**Pipeline and Hazardous
Materials Safety
Administration**

Reference No. 16-0151

This letter is in response to your September 13, 2016, letter requesting clarification of the Hazardous Materials Regulations (HMR; 49 CFR Parts 171-180) applicable to the permanent installation of delivery hose assemblies on MC331 cargo tanks. You describe a scenario in which the delivery hose assembly is attached to a fitting coming from the unloading outlet while in transportation. You provide in your letter several photographs of delivery hose configurations and ask whether any of the configurations constitute non-compliance with the HMR—and specifically, which requirement.

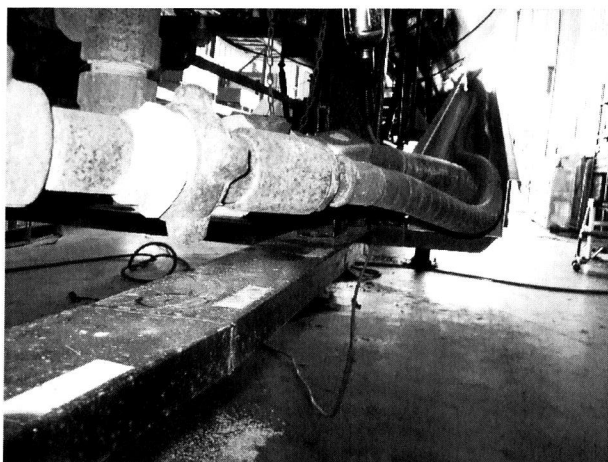
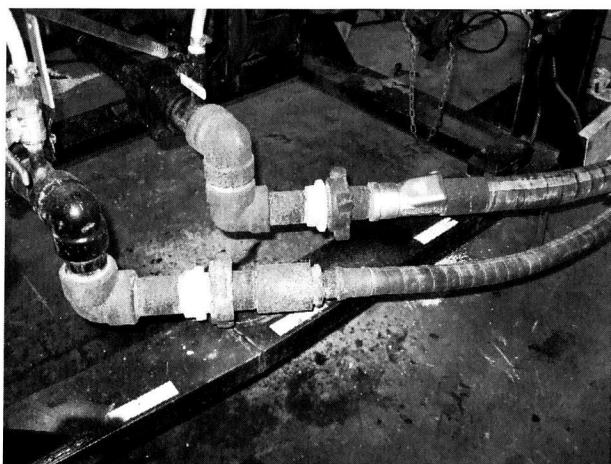
1. These three pictures are all of the same cargo tank motor vehicle. This is an MC331 cargo tank transport in non-metered delivery service. A Smart Hose is being used to unload. Is this a violation to have the hoses permanently attached and being transported in the hose tray? If it is a violation what is the cite for this violations. These three pictures are referenced as exhibit number 1.

Based solely on the photographs provided, this Office cannot determine whether each configuration would comply with the HMR, except for the scenario in which the ACME fitting is clearly outside of the protective and, therefore, non-compliant. Section 178.337-10(a) states that all valves, fittings, pressure relief devices, and other accessories to the tank proper shall be protected in accordance with paragraph (b) of this section against such damage as could be caused by collision with other vehicles or objects, jack-knifing, and overturning. All fittings, including the ACME fitting, and couplings of a delivery hose assembly, but not the hose itself, on an MC331 cargo tank would be considered a fitting or other accessory to the tank. Therefore, in accordance with § 178.337-10(b), for a delivery hose assembly to remain connected to an MC331 cargo tank while in transportation, all of the fittings and couplings (1) must have a protective device or housing designed to withstand static loading in any direction equal to twice the weight of the tank and attachments when filled with the lading, using a safety factor of not less than four, based on the ultimate strength of the material to be used, without damage to the fittings protected, and (2) must be made of metal at least 3/16-inch thick.

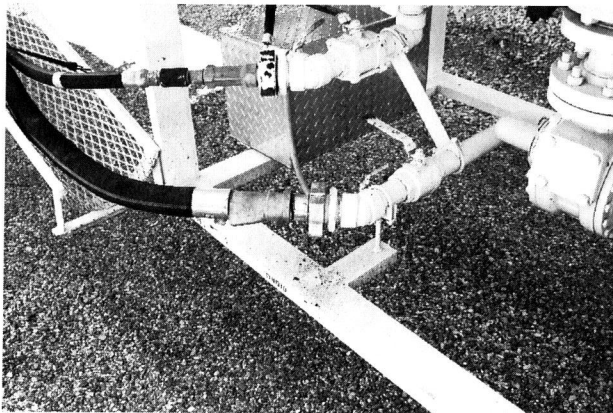
2. These two pictures are all of the same cargo tank motor vehicle. This is an MC331 cargo tank transport in non-metered delivery service. A Smart Hose is being used to unload. Is this a violation to have the hoses permanently attached and being transported in the hose tray? If it is a violation what is the cite for this violations. These three pictures are referenced as exhibit number 2.

Does it make any difference that the hose assembly is actually attached to the ACME fitting inside the piping protection framework but there is not at least a 6 inch gap between the piping protection and the rigid piping?

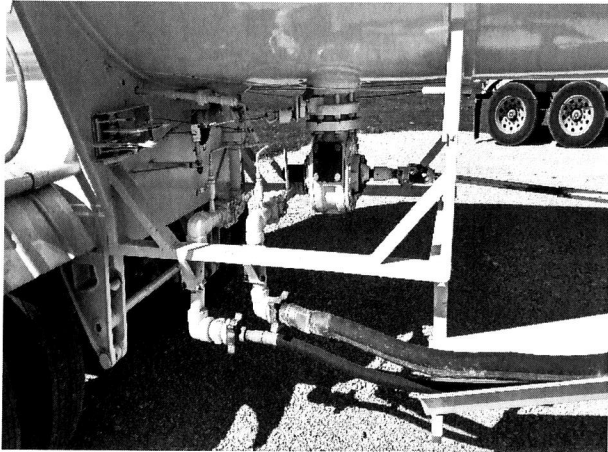
3. These three pictures are all of the same cargo tank motor vehicle. This is an MC331 cargo tank transport in non-metered delivery service. A Smart Hose is being used to unload. Is this a violation to have the hoses permanently attached and being transported in the hose tray? If it is a violation what is the cite for this violations. These three pictures are referenced as exhibit number 3.

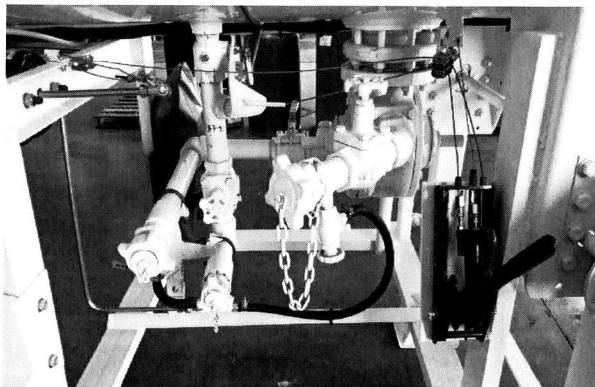
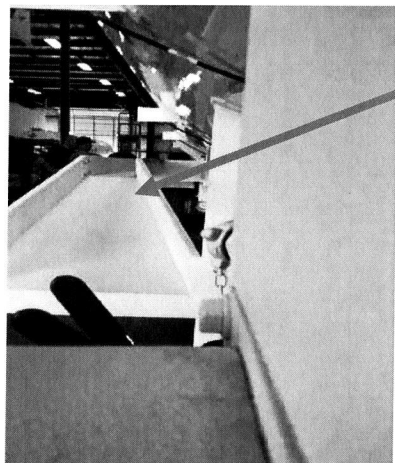
4. These three pictures are all of the same cargo tank motor vehicle. This is an MC331 cargo tank transport in non-metered delivery service. A Smart Hose is being used to unload. Is this a violation to have the hoses permanently attached and being transported in the hose tray? If it is a violation what is the cite for this violations. These three pictures are referenced as exhibit number .4

Note the ACME fitting is actually outside the piping protection

Here is the hose tray where the delivery hose will be transported when not in use

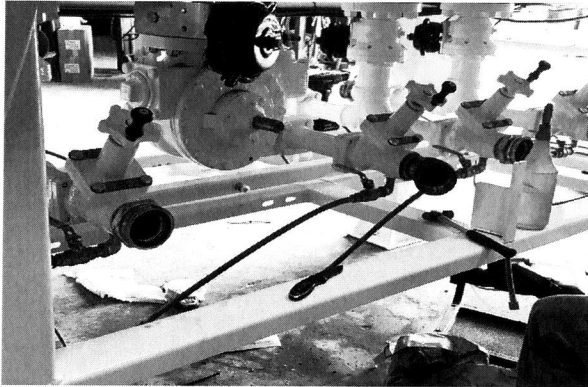
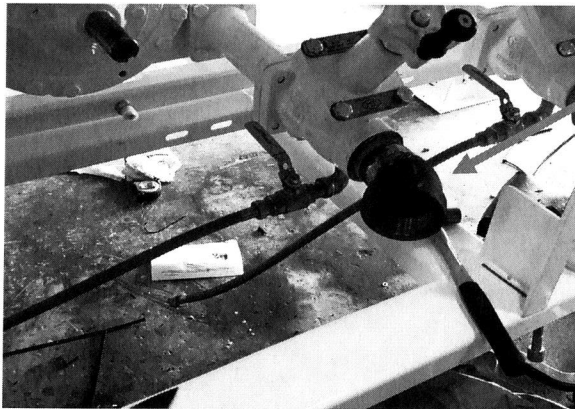
5. These three pictures are all of the same cargo tank motor vehicle. This is an MC331 cargo tank transport in non-metered delivery service. A Smart Hose is being used to unload. Is this a violation to have the hoses permanently attached and being transported in the hose tray? If it is a violation what is the cite for this violations. These three pictures are referenced as exhibit number .5

Note the piping where the ACME fitting is actually connected is inside the piping protection but you still do not have a minimum of 6 inch clearance. Does the six inch clearance really matter if the 12 to 16 inch rigid part of the delivery hose assembly end actually extends beyond the piping protection.
